Re: Nantucket Public Schools: Campus Wide Master Plan

RE: Review of NPS Athletic Improvements Design and Testing Information

The Horsley Witten Group, Inc. (HW) has reviewed the materials provided by the Nantucket Land Council (NLC) related to soil and material testing data, proposed stormwater management, and special permit considerations for the NPS Campus Athletic Improvement Plan. The proposed project is not part of an active permit application; thus, our review should be considered preliminary in nature. Our comments are intended to support NLC in evaluating potential concerns and opportunities associated with the project.

Figure 1. Drainage map and discharge locations in question

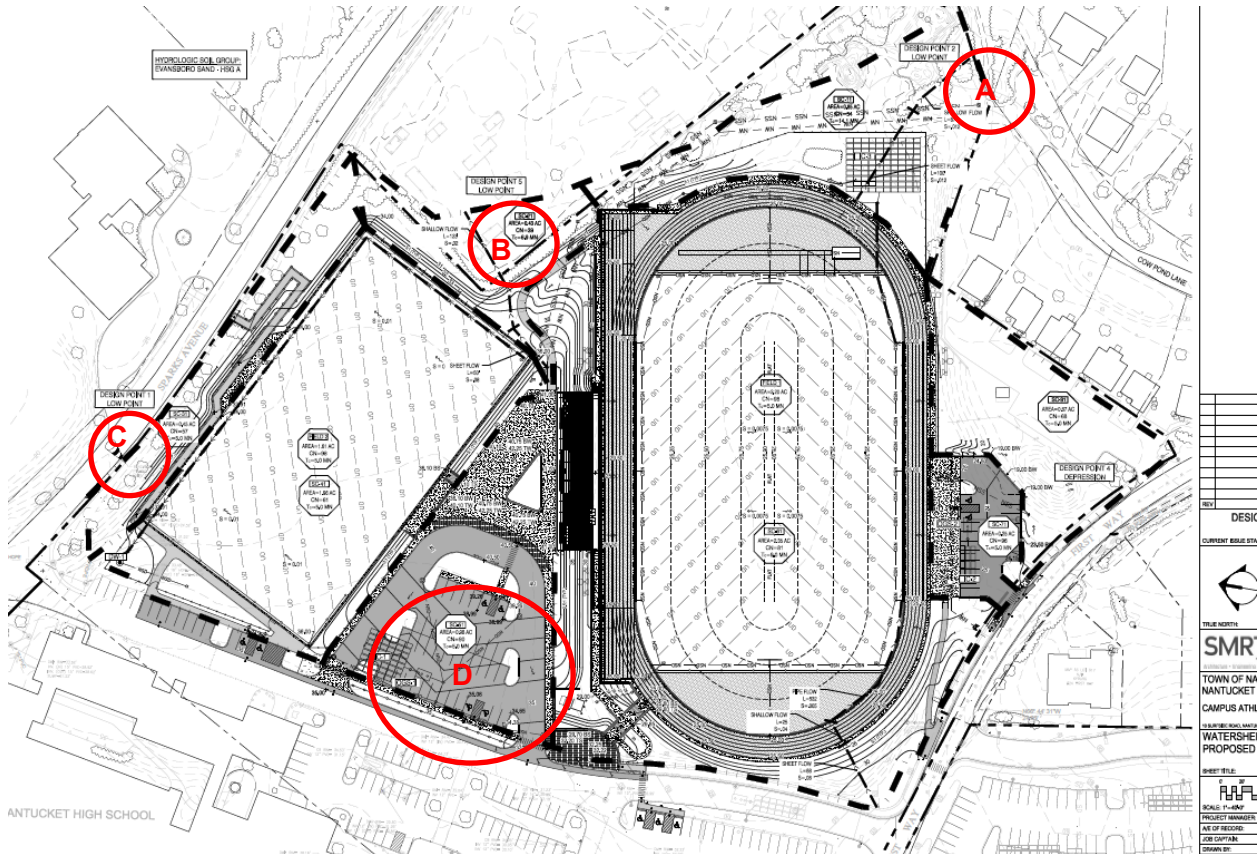
The applicant should be asked for more information regarding offsite discharge at the following four locations (**Figure 1**):

- a. Cow Point Road/residential neighborhood: The applicant states in the drainage report that *“The 100-yr post development flow at DP-2 is exceeded by 6.61 cfs. This area will continue to drain to a low point at the end of Cow Point Road. This area is large enough to contain runoff from this storm so it can infiltrate, and offsite flooding is not anticipated.”* What is the expected volume of overflow and how does applicant know Cow Point Rd. will not flood? How does excess flow leave the piped system/chambers?

- b. DP 5: The applicant states in the drainage report that *“The addition of Design Point 5 also indicates minimal flow off site. The peak runoff for the 2, 10, and 100-year flows do not exceed 1 cfs, indicating minimal runoff. The geotechnical infiltration indicated sandy soils which infiltrate stormwater very quickly across the site. Due to the low runoff flows and existing soil conditions offsite flooding is not anticipated.”* There is no threshold where 1 cfs is considered de minimis. More information is needed.

- c. Sparks Ave: The applicant states in the drainage report that *“Due to the proposed layout, the area between Field 2 and Sparks Ave cannot feasibly be directed toward a treatment BMP. The only proposed improvement is the accessible ramp connecting Field 2 to the existing sidewalk. However, water will collect in a depression along the vegetated shoulder which will provide some treatment before entering the groundwater table.”* Maybe this is a good place for a rain garden?

- d. Loop parking and plaza: The HydroCAD model also shows overflow from SC-51 (the new 1-acre loop parking area) during the 100-yr event, but this area is not included as an analysis point in the Table on page 8 of the drainage report.
